Application for Certificate of Appropriateness

Address of Subject Property: 1168 Clifton Road NE Atlanta GA 30307

1168 Clifton Road, Decatur, Georgia 30307
Supporting Document to COA Application

From: Anastasiya Arina <aa@mararigroup.com>
Sent: Friday, January 13, 2023 9:31 AM
To: Cullison, David
Cc: Bragg, Rachel L.
Subject: Re: 1168 Clifton Rd

A-2A

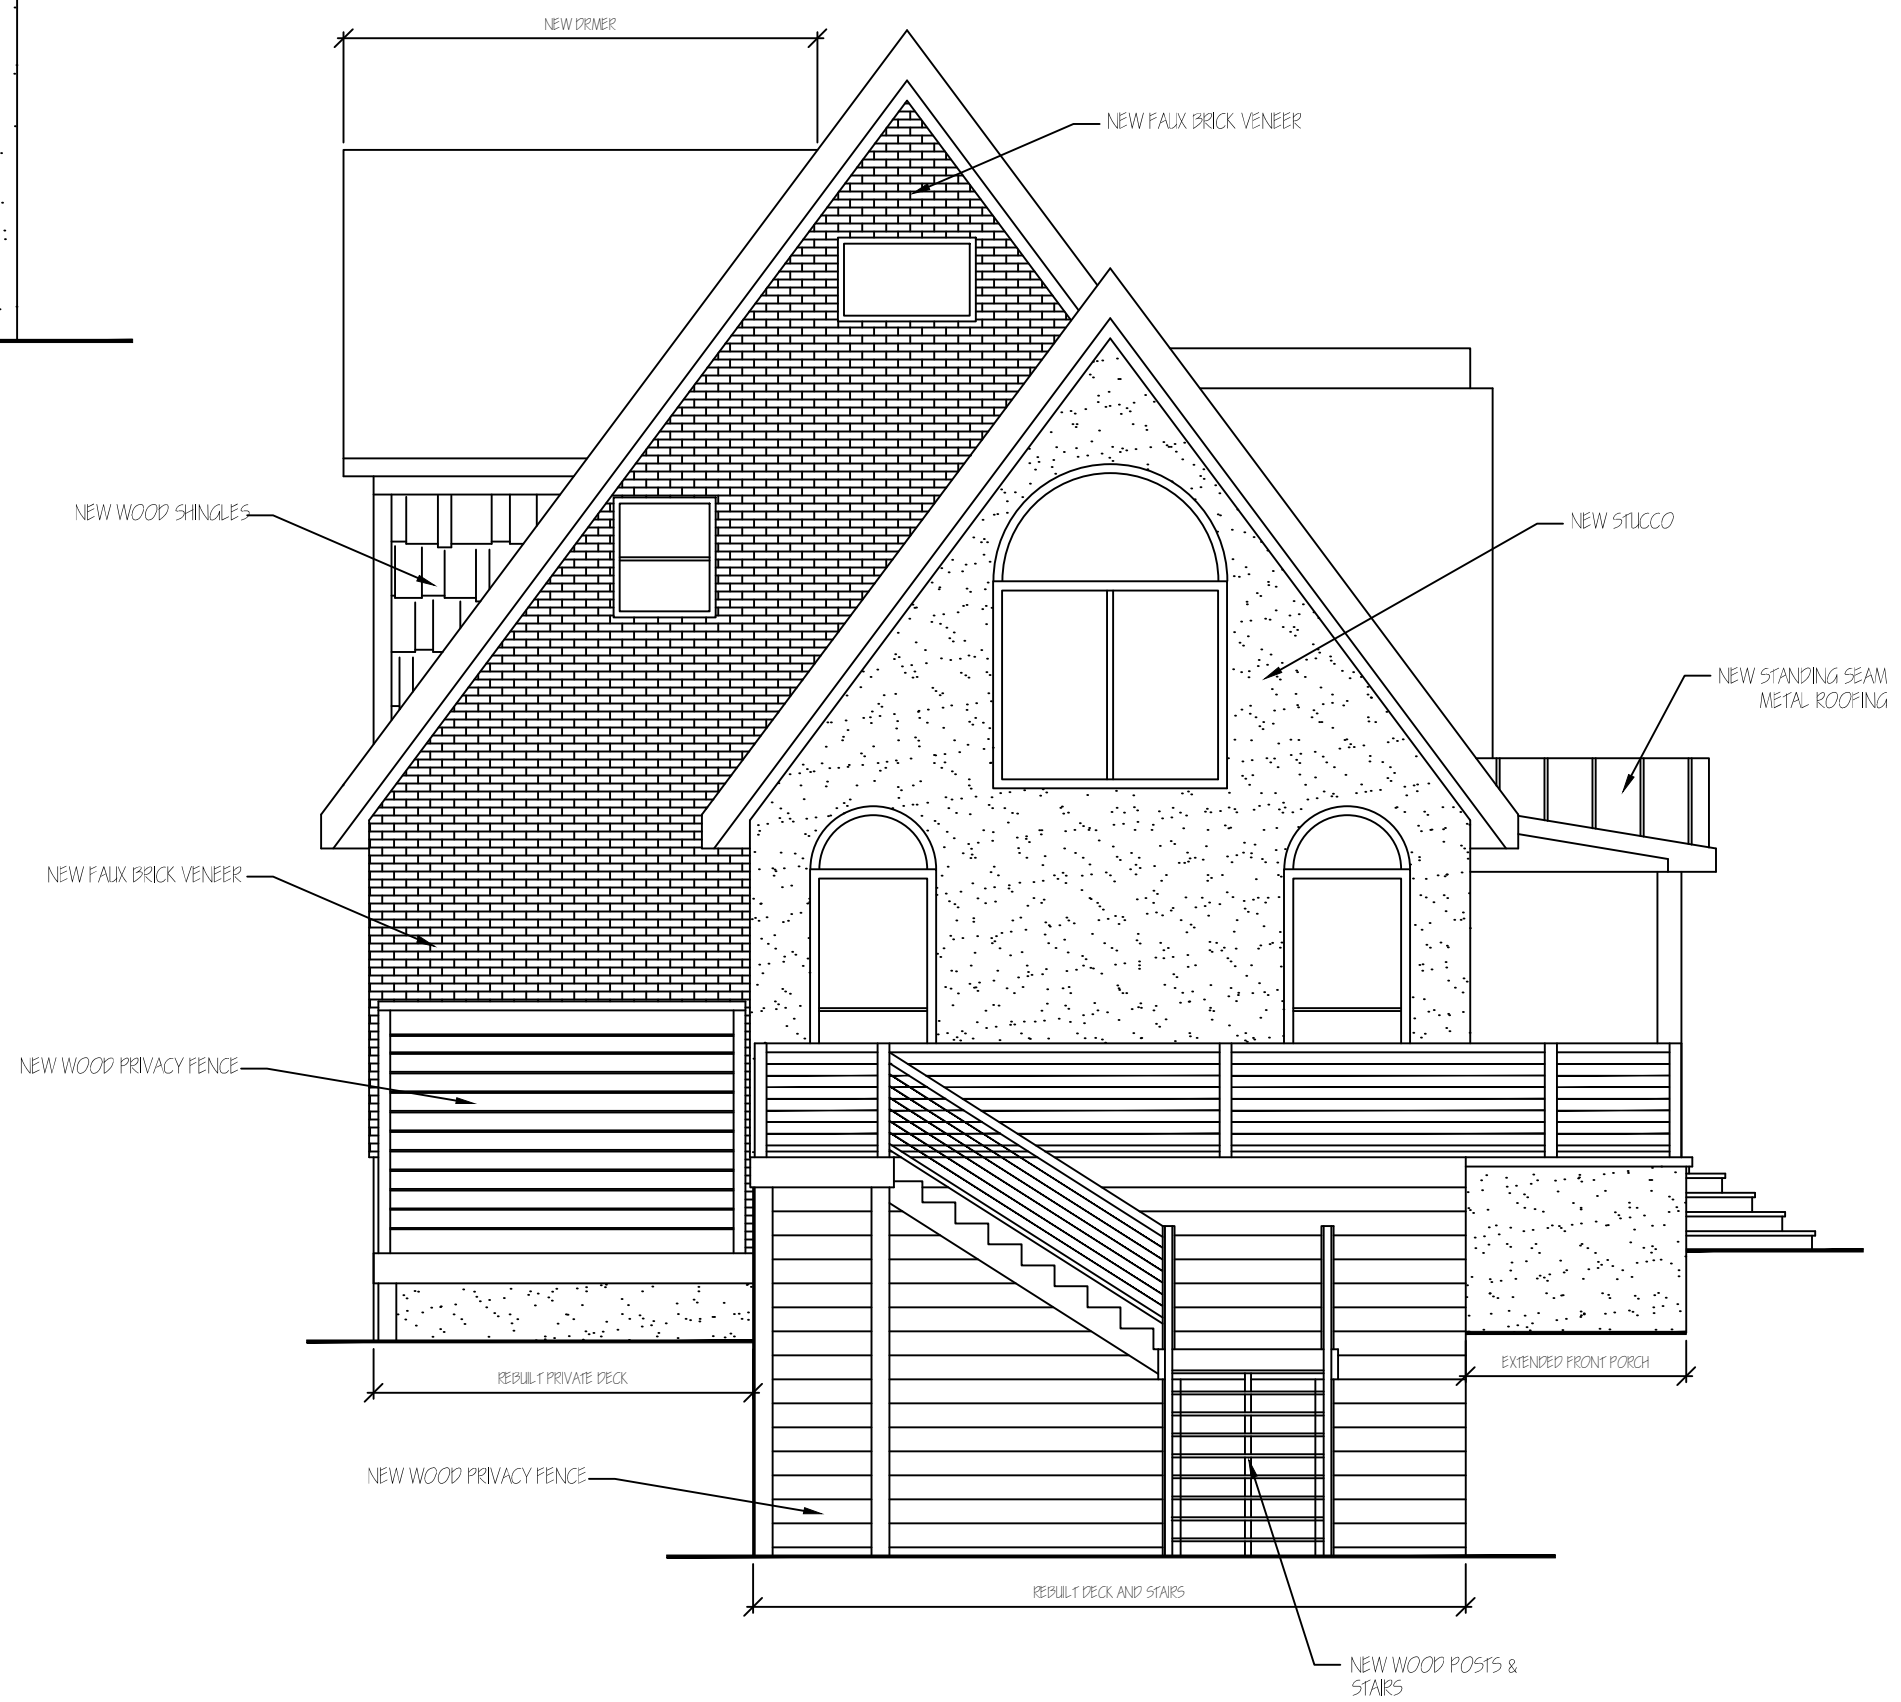
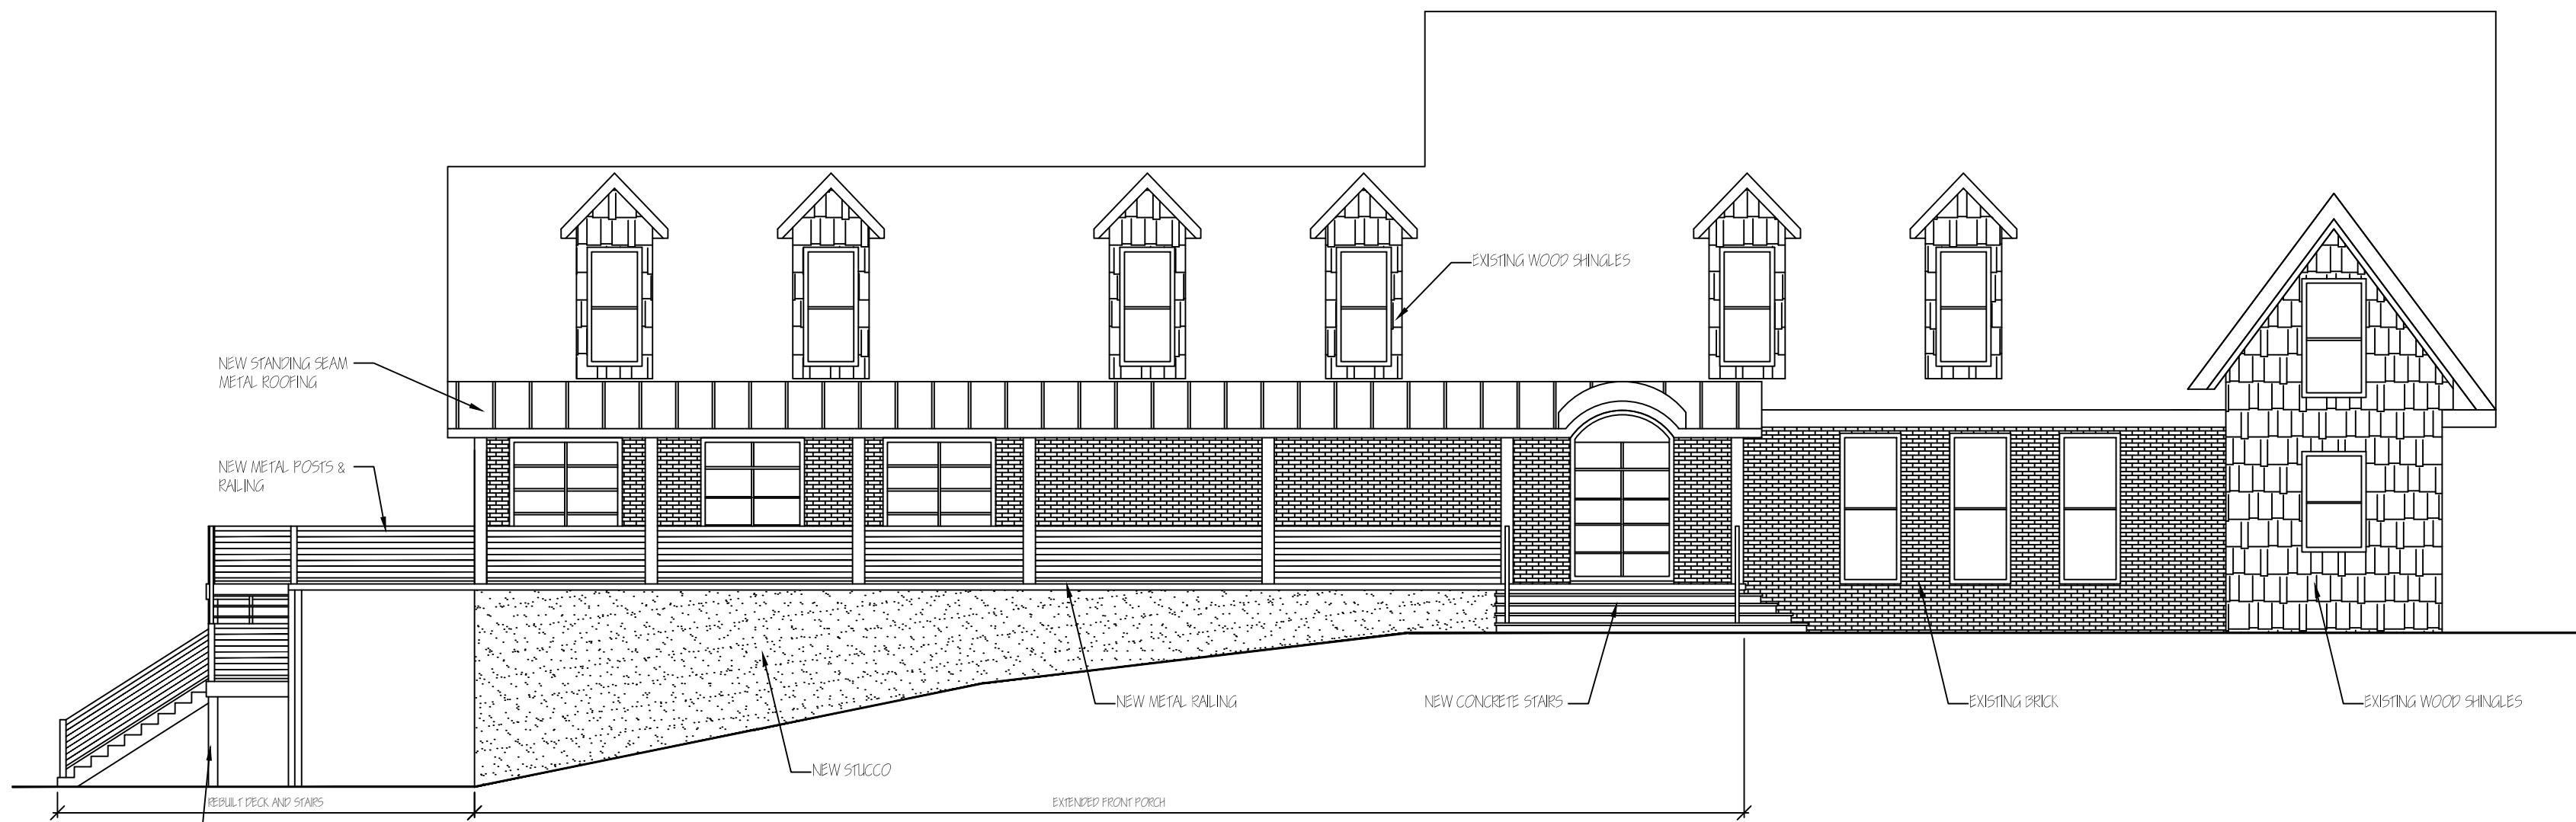
Right and left side elevations appear to be reversed.

Right and left side elevations appear to be reversed.

A-2

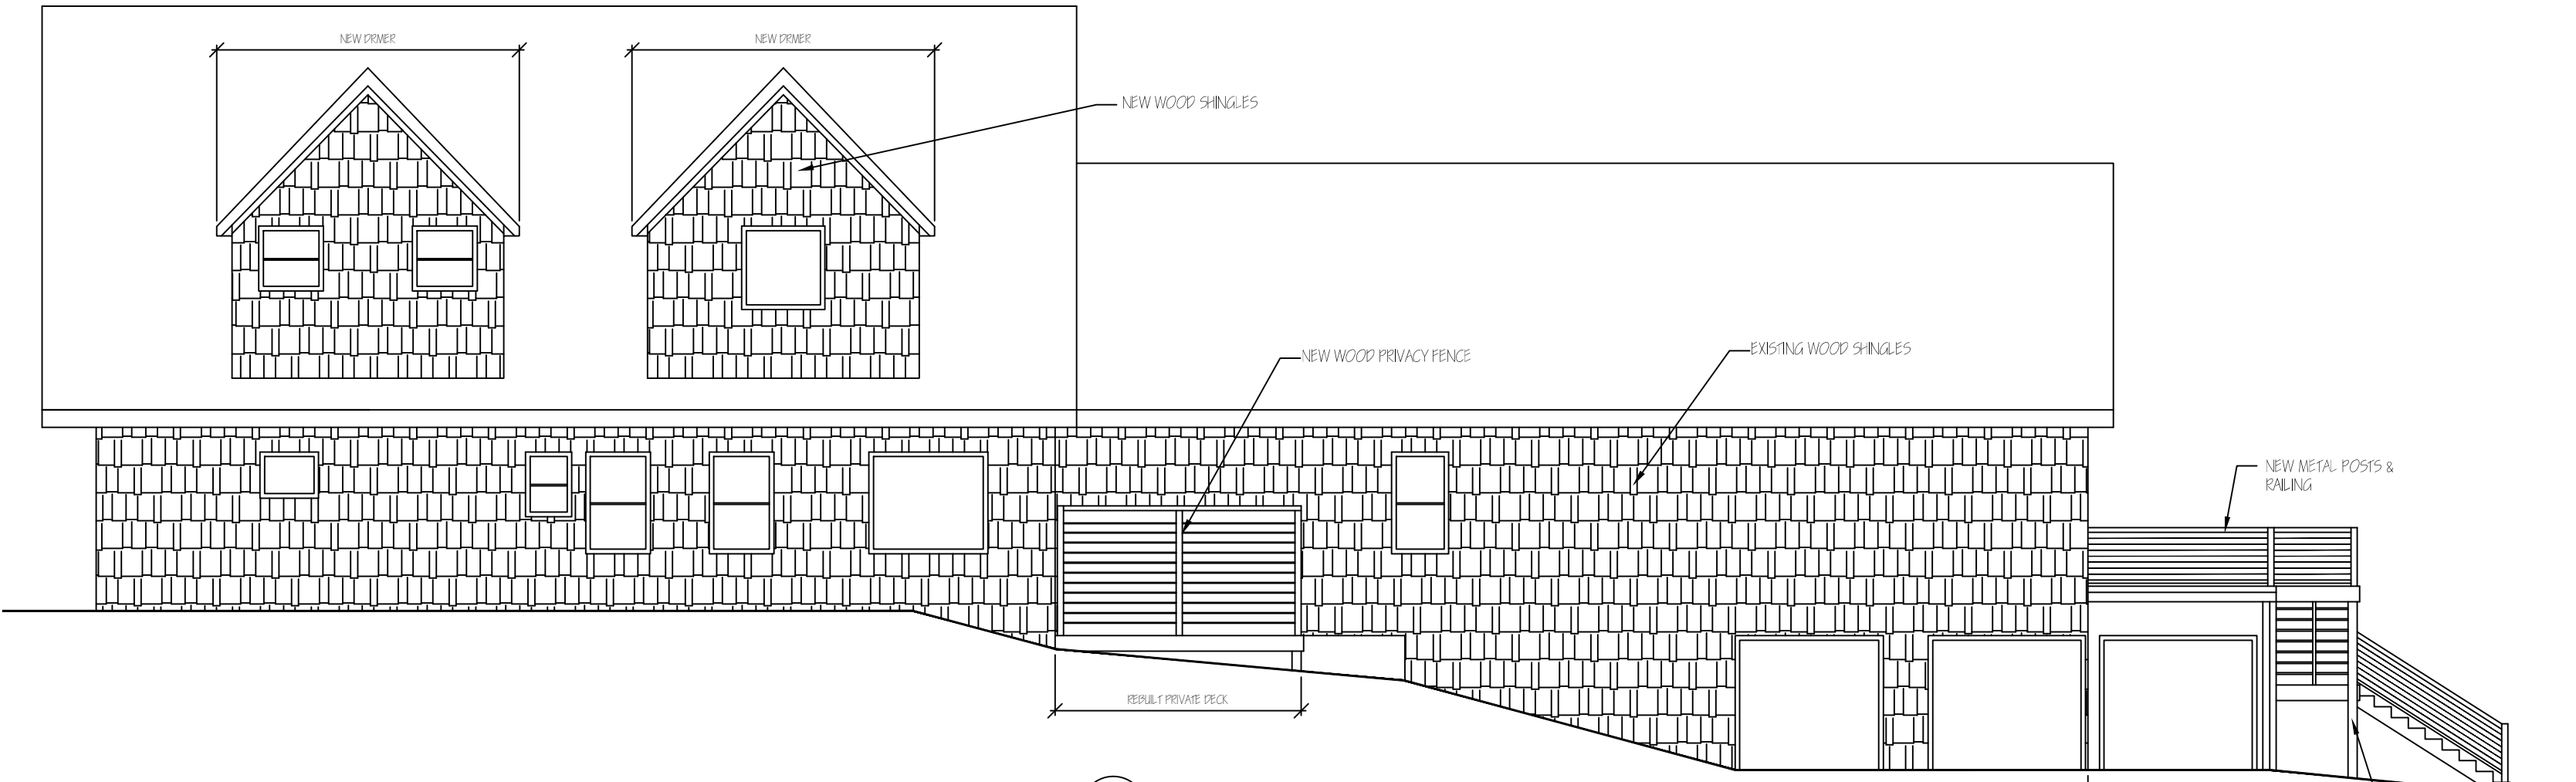
Pictures show vertical balusters on the railing, but the drawings show horizontal. Please clarify.

Pictures show vertical balusters on the railing, but the drawings show horizontal.

- 1) Railing will be vertical, metal.
- 2) windows with grid (on the website it referenced style as colonial .)
- 3) are you asking for the brand ? I would like to use think brick sheets on the back porch elevation so we do not have to extend the roofline. Here is a sample of the product.
